MEMORANDUM

Re: **Clean Water Act Section 401 Certification of the Rosemont Copper Mine**

The Honorable Chair and Members, Pima County Board of Supervisors
Re: **Rosemont Copper Mine Section 401 Certification**
March 27, 2015
Page 2

Appendix 2. Graphical Representations of Davidson Canyon Streambed versus Groundwater Elevations

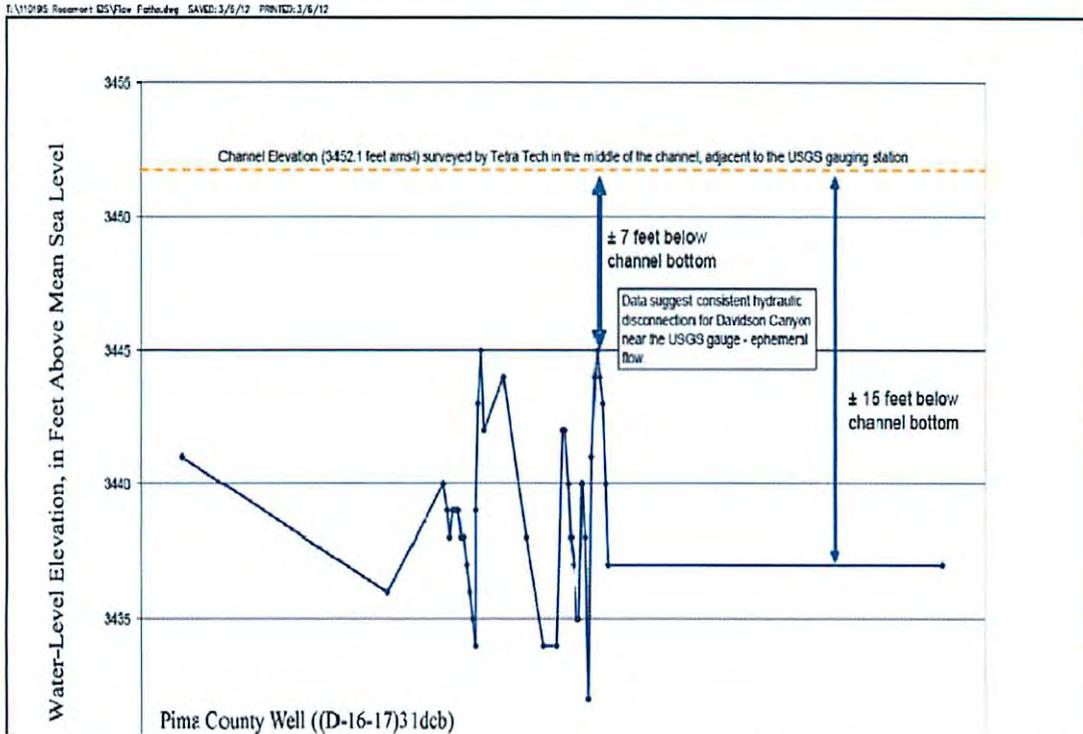
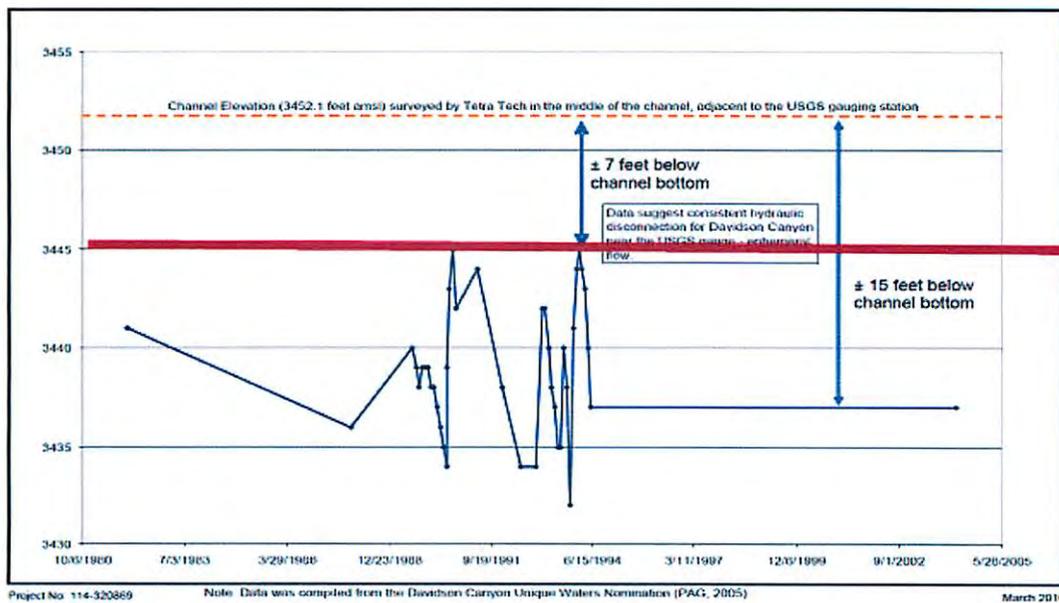
Figure 1 of Appendix 2 hereto is a graph⁵ produced by Rosemont purporting to show groundwater elevations significantly below stream bed levels. Figure 2 in Appendix 2 hereto is the same graph⁶ but with corrected stream bed elevations. The corrected cross-sectional data demonstrate that the following conclusions from Rosemont’s Davidson Canyon Conceptual Groundwater Monitoring Plan⁷ are incorrect:

Figure 1. Figure provided by Rosemont (Tetra Tech 2010a) which shows incorrect bed elevation.

Figure 2. Powell (2104) correction of the stream bed elevation shown in Figure 1, above.

FIGURE 8. GRAPH OF DEUTERIUM VERSUS DELTA OXYGEN-18 FROM WELLS, SPRINGS, AND SURFACE WATER LOCATIONS, APRIL THROUGH OCTOBER 2008, ROSEMONT AREA

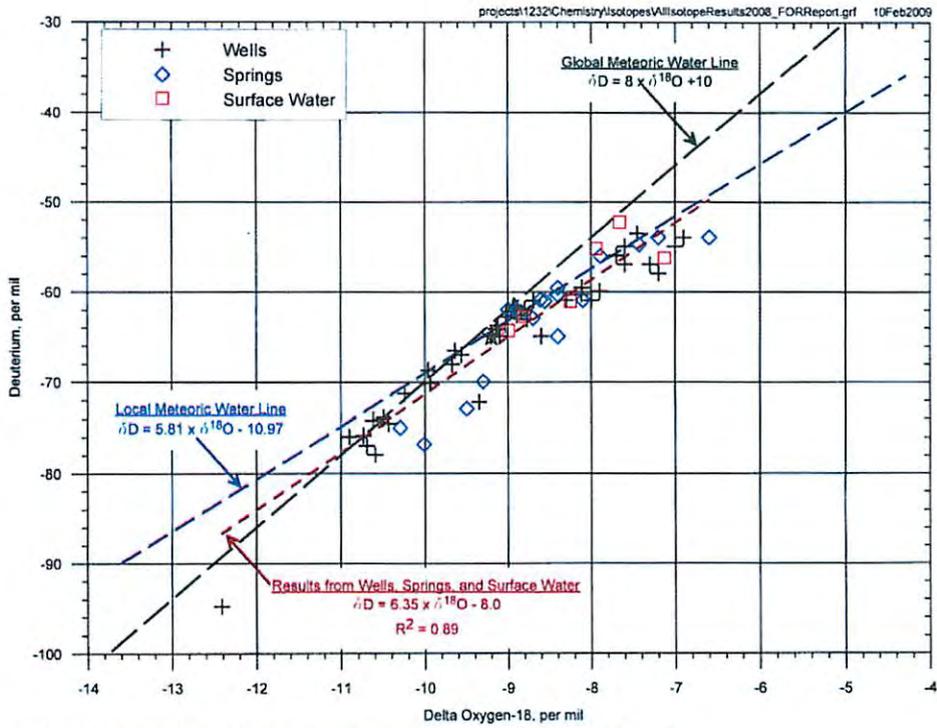
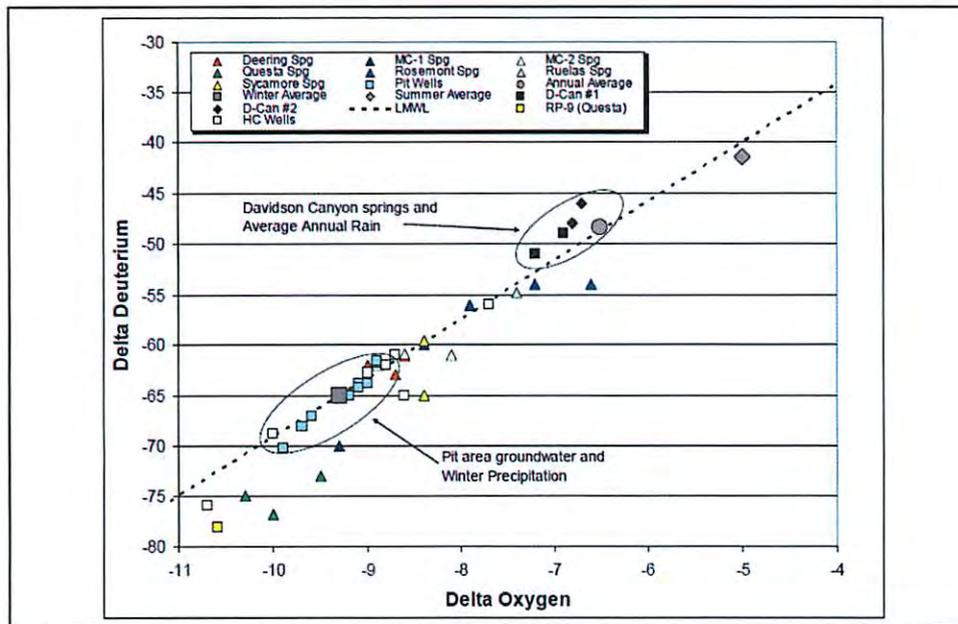
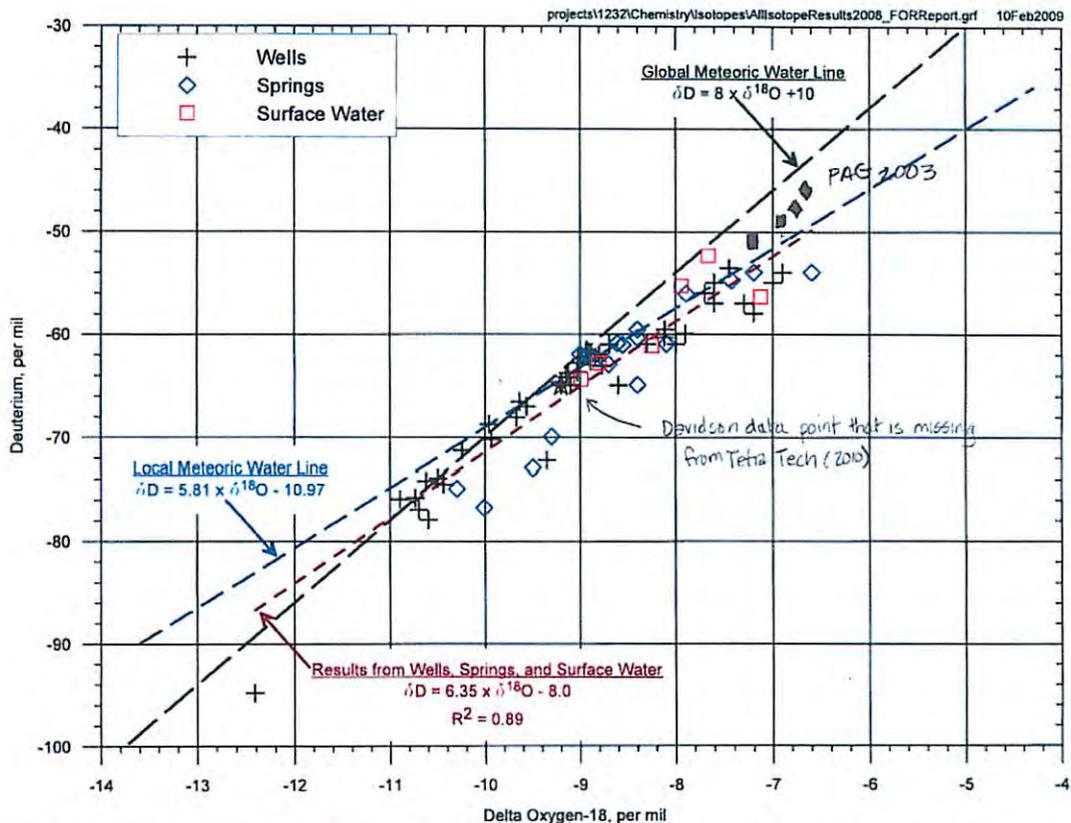
Some of these same data are shown on Figure 17 from Tetra Tech (2010), which differentiates the pit area groundwater (primarily PC well series) from other wells and springs in the mine vicinity. While it is true that the pit well data are largely grouped in the lighter oxygen values, many of Montgomery's other well and surface water data plot right along the red line calculated by Montgomery using the entire data set, suggesting that they are from the same population.

4. Referencing Montgomery's Figure 8 again, note that all of the samples, even the PC wells, plotted below the Global Meteoric Water Line. This is not disclosed by Tetra Tech, and in fact the Tetra Tech plot actually obscures this fact by plotting a dashed line that does not represent the Global Meteoric Water Line. It can be seen that the intercept of Tetra Tech's line is much lower than the Global Meteoric Water Line that Montgomery shows. The slope of the local data, and the values of the PC wells considered as a group *both show substantial influence from natural evaporation during precipitation, runoff and / or recharge*, as was noted by Montgomery and Associates in their 2009 report. Tetra Tech did not discuss Montgomery's observation of an evaporative effect, presumably because it did not fit their preferred interpretation.

5. Tetra Tech's Figure 17 includes a data point representing winter average rainfall. This value is important because it is the principal basis for the inference that the position of the "*pit area groundwater*" on figure 17 means that *winter precipitation* is the source of the groundwater for the PC wells. Tetra Tech says that the winter average value is based on "*stable isotope data for local precipitation*" by Wagner (2006). Page 124 of Wagner 2006 provided several years of precipitation data from the vicinity of Cave of the Bells, in the Santa Rita mountains farther south. There were too few years in Wagner's sample to define a local meteoric water line (Dr. Chris Eastoe, personal communication).

6. Figure 8 (Montgomery and Associates 2009) also has a local meteoric water line (LMWL) derived from data provided by Dr. Chris Eastoe. In attachment 3, Dr. Eastoe presents a more robust dataset for a LMWL. LMWL's are important because they provide a basis for interpreting sample results.

10. Tetra Tech omitted well data that did not support their hypothesis. Tetra Tech's Figure 17 omits many of the wells and spring samples that plotted closer to the PAG dataset, but retained the "pit wells" that favored Tetra Tech's interpretation. The omitted samples that plotted closer to the PAG data set included wells RP-4A and RP-3A located in areas under the waste rock and tailings landform, and Rosemont spring, which would also be covered with waste rock and tailings.

Figure 6. Tetra Tech’s (2010a) Figure 5, amended to show actual channel bed elevation at the location. Red line shows position of the 2008 and 2011 channel bed based on LiDAR data.

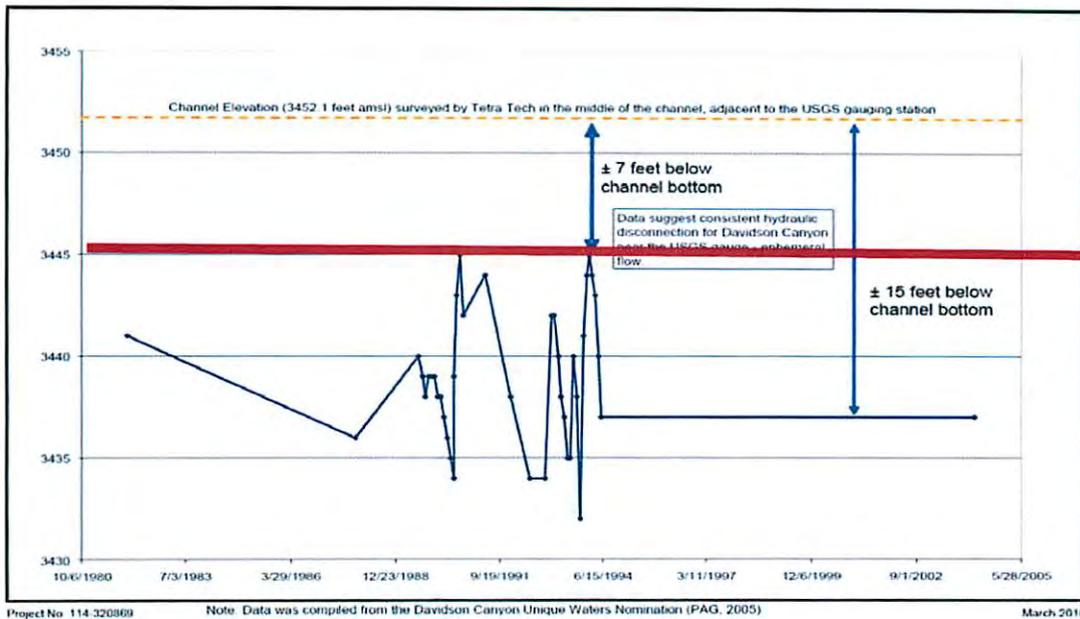
We also take issue with Tetra Tech (2010a) data. Underpinning Tetra Tech's assertion is an illustration and a channel bed measurement at the Davidson Canyon stream gage (Figure 6). The accuracy of this figure relies on a "mid-channel bed" measurement taken by Tetra Tech (2010a). We examined Pima County LiDAR-generated elevation data at the same location and found that Tetra Tech's "mid-channel" bed elevation is five feet higher than the channel bed in 2008. We then examined 2011 LiDAR bed-elevations at the same location, which rule out the possibility that five feet of aggradation occurred, as would be required by Tetra Tech channel bed measurement. Instead, the actual bed elevations in 2008 and 2011 vary by less than 0.6 feet (Figure 7). Thus, the actual channel-bed is within a foot or two of the water table as measured in Davidson #2 Well.

The water-level measurements presented by Tetra Tech came from the Outstanding Waters nomination submitted by Pima Association of Governments (2005), which identified this reach as intermittent. Tetra Tech (2010a) uses the same data to infer that this portion of the channel is ephemeral. It is unreasonable to assume that groundwater never could discharge to the surface, or that it has been persistently below the bed between 1994 and 2004, as is indicated by Tetra Tech with the horizontal line connecting the last two groundwater measurements (Figure 6). It is even more unreasonable to extend that inference to the entire upstream reach, as is done by Tetra Tech (2010a).
